Chester Square Planning Proposal

Peer Review

Transport Impact Assessment

Prepared by: GTA Consultants (NSW) Pty Ltd for City of Canterbury Bankstown

Figure 3.1: Potential directional distribution

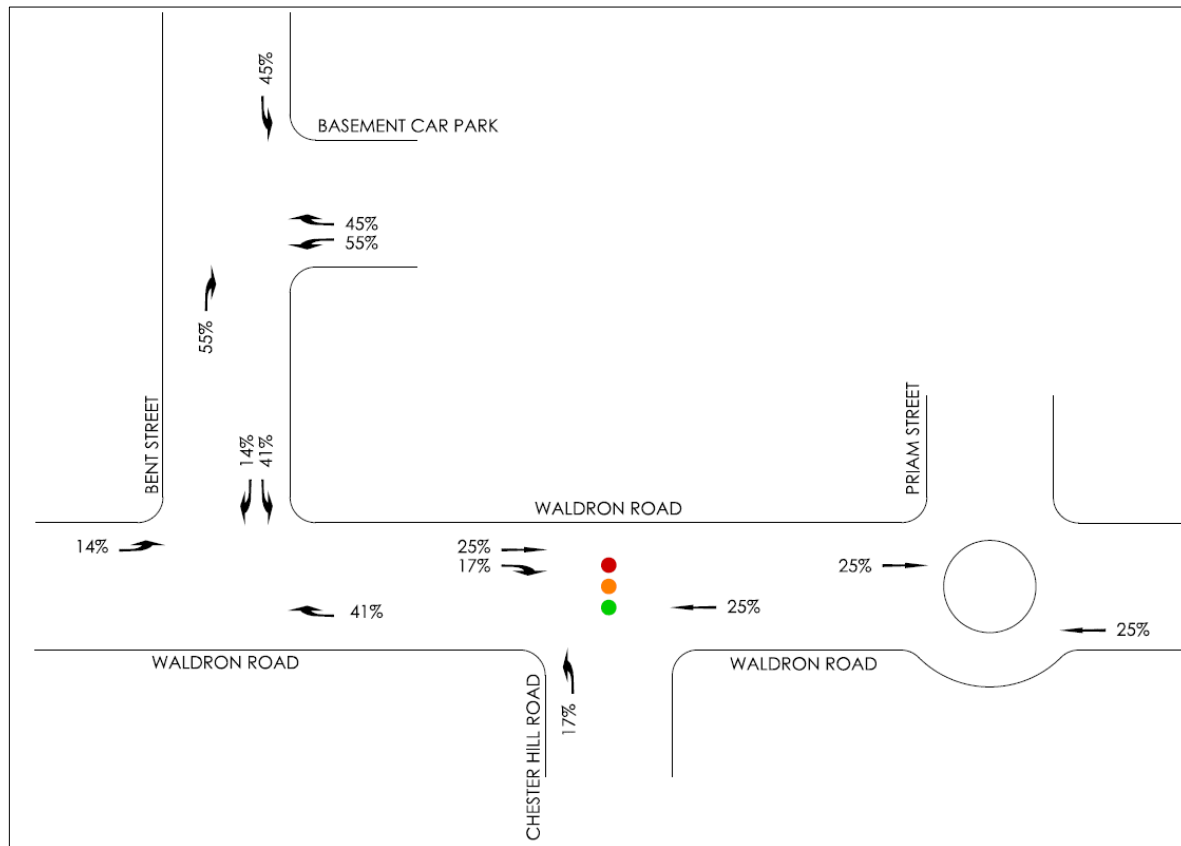
While there is an obvious residential catchment north and east of the site, the catchment south of the site is arguably equal or larger. Connections with key roads in and out of the local area should also be considered when assigning development traffic.

GTA has completed an analysis of the existing traffic volumes detailed in Section 3.4.2 of the Chester Square TIA and represent a more considered traffic distribution based on the single access on Bent Street. This is as follows:

Based on the above analysis, the traffic distribution shown in Figure 3.1 is considered more appropriate for assessing development traffic, albeit while maintaining the assumption of just a single site access on Bent Street (which is impractical in itself).

Figure 3.2: Chester Square TIA Waldron Road mitigated layout

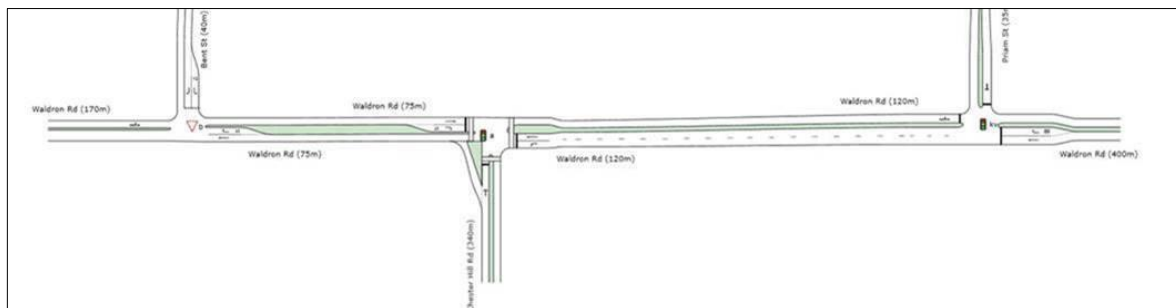
Section 2.4 of the Transport for NSW Traffic Signal Design guidelines states that a signalised marked foot crossing must be provided on each leg of a signalised intersection, whereas the proposed mitigated layout included in the Chester Square TIA does not include any marked foot crossings on any of the approaches. This will ultimately result in more favourable modelling results in SIDRA though we note uncertainty as to any such specific reasons for omitting the crossings.

- Modelled mitigation measures for the Priam Street/ Waldron Road do not align with Transport for NSW requirements for signalised intersections.

Preliminary SIDRA modelling was completed on the proposed mitigated layout with the inclusion of the marked foot crossings at the Waldron Road/ Priam Street intersection based on the anticipated distribution discussed in Section 3.4.2 of this assessment. The results indicate that the Waldron Road/ Chester Hill Road intersection would exceed its capacity. However, modelling indicates that a satisfactory level of service could potentially be achieved by lengthening the right turn bay from Waldron Road to Chester Hill Road to extend to Bent Street to increase its capacity. This would likely result in the loss of around 10 on-street parking spaces on the northern side of Waldron Road. The existing arrangement for the left turn lane from Waldron Road to Chester Hill Road was also maintained for the modelling, whereas this was extended in the Chester Square TIA.
